Visalia Convention Center
Hearing on the Draft EIR
Cross Valley Loop

I have 4 concerns with the Draft EIR:

7
GATEWAY TO SIOUXIA PARK

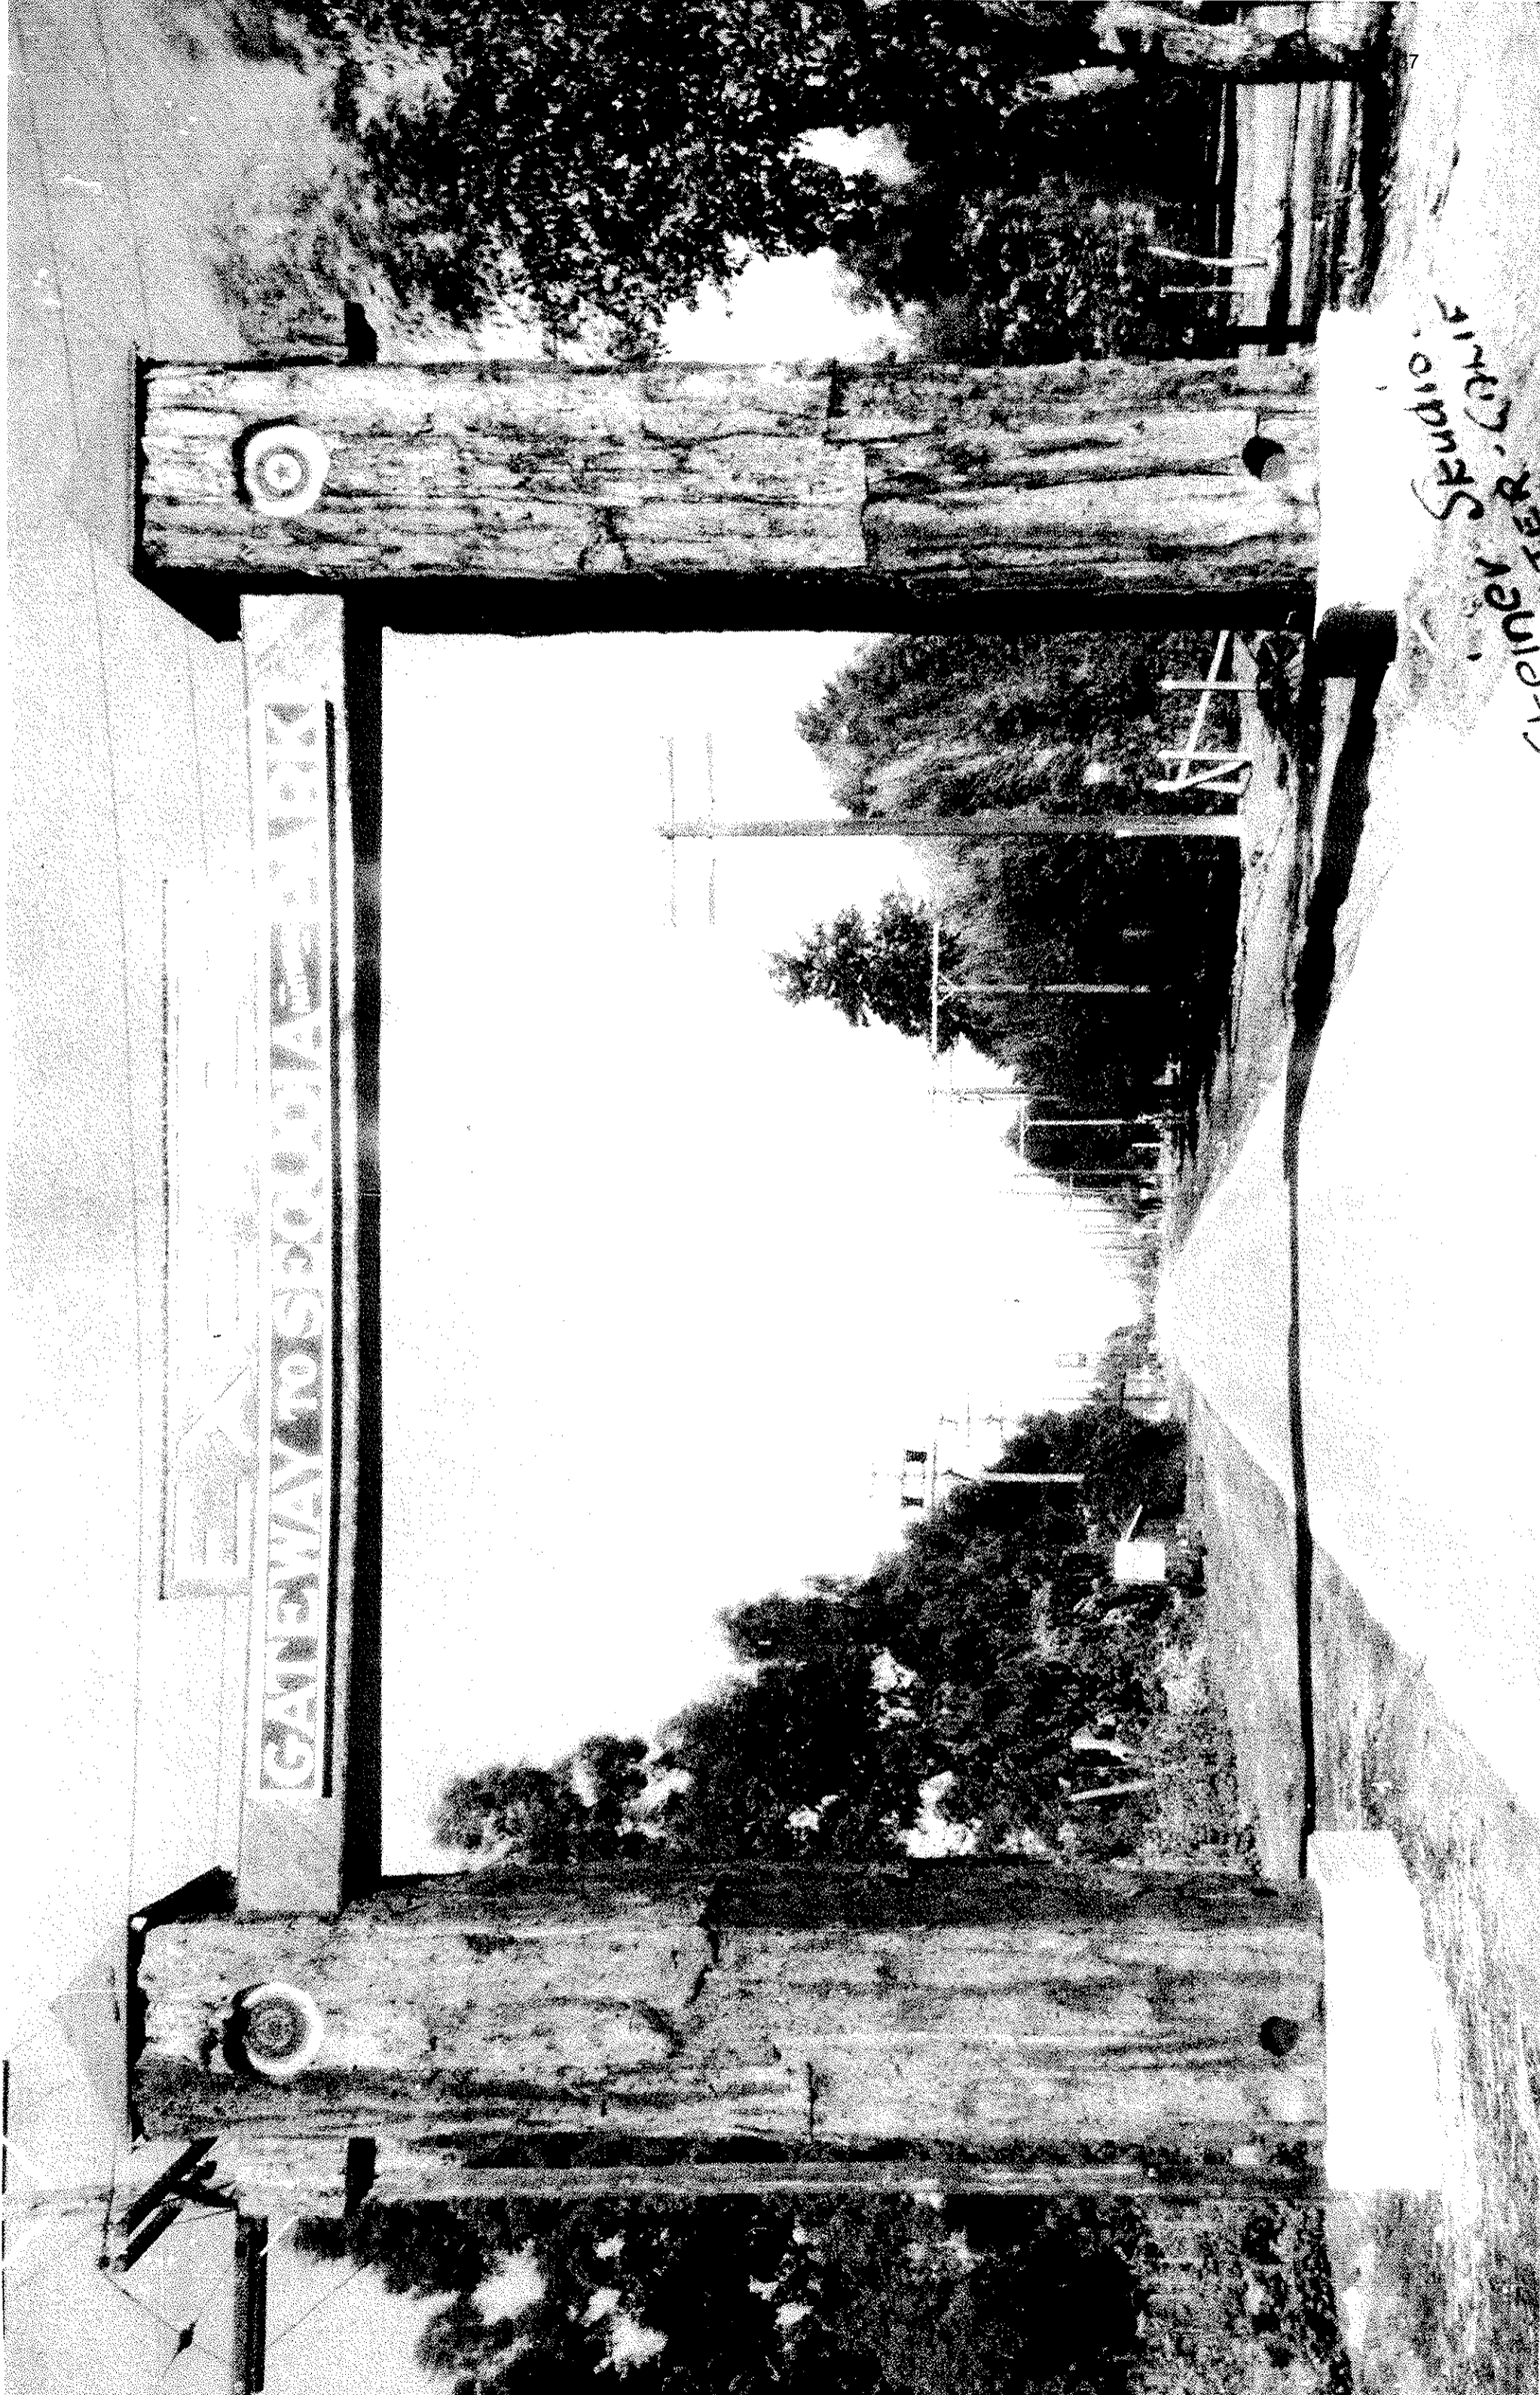
- 1) 4.1-1a Highway 198 is the scenic corridor to the Sequoia National Parks. In 1925 the entrance to Exeter had an archway with a sign stating "Gateway to the Sequoia National Parks". We all know this beautiful view as we travel eastward towards Exeter. The EIR Mitigation Measure 4.1-1a states the visual impact is less than significant or Class 3. It shows a picture (Figure 4.1-7b) of a simulated view of the 160 foot towers. You can barely see these towers in the simulated picture. In real life you will be able to see them, and that will be significant. I believe this simulation is wrong and should be corrected to what it will actually look like.
